ADDENDUM NO. 1

DATE: February 20, 2024

SUBJECT: Addendum No. 1 – Strafford Water Town Water Main
Cochran Project No. SW23-593

WATER MAIN #1
PLAN AND PROFILE

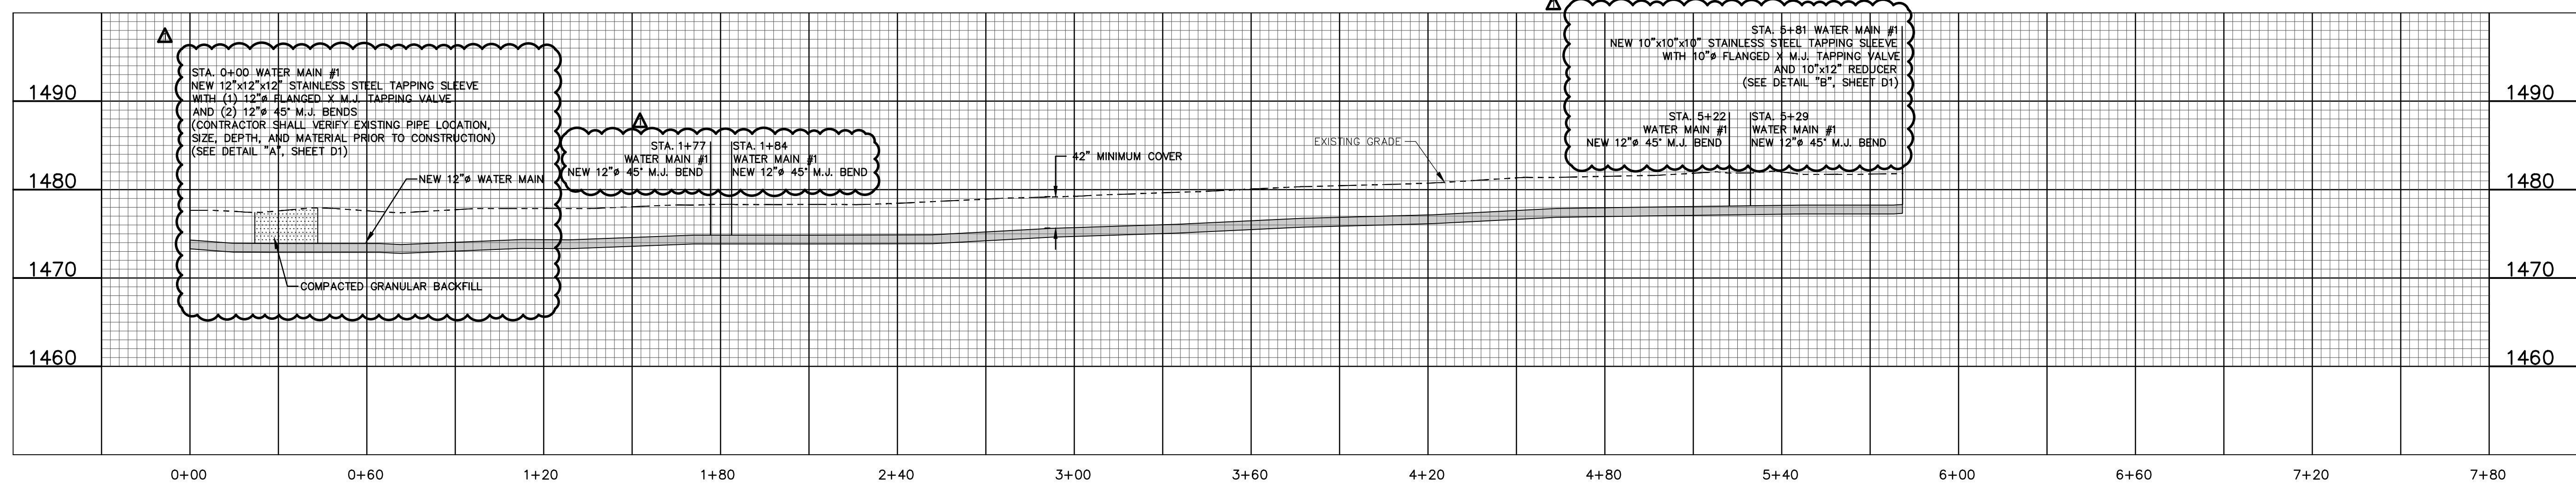
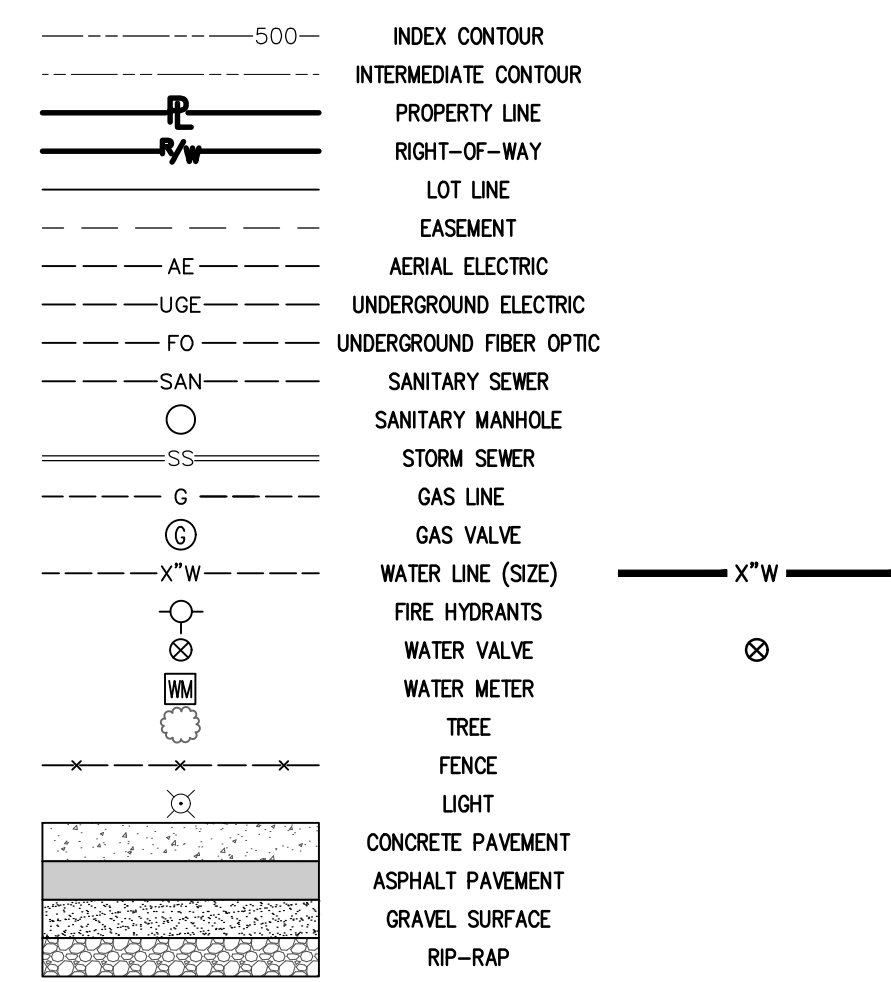
1. Title Sheet
 - a. 12" Diameter SDR 21 Class 200 PVC Water Main quantity updated.
2. C1 – Water Main #1 Plan and Profile
 - a. Updated alignment to remove approximately 137 LF of 12" diameter pipe at the south end.
 - b. Updated all stationing to reflect new alignment.
3. D1 – Detail Sheet
 - a. Updated station reference in Detail "B".
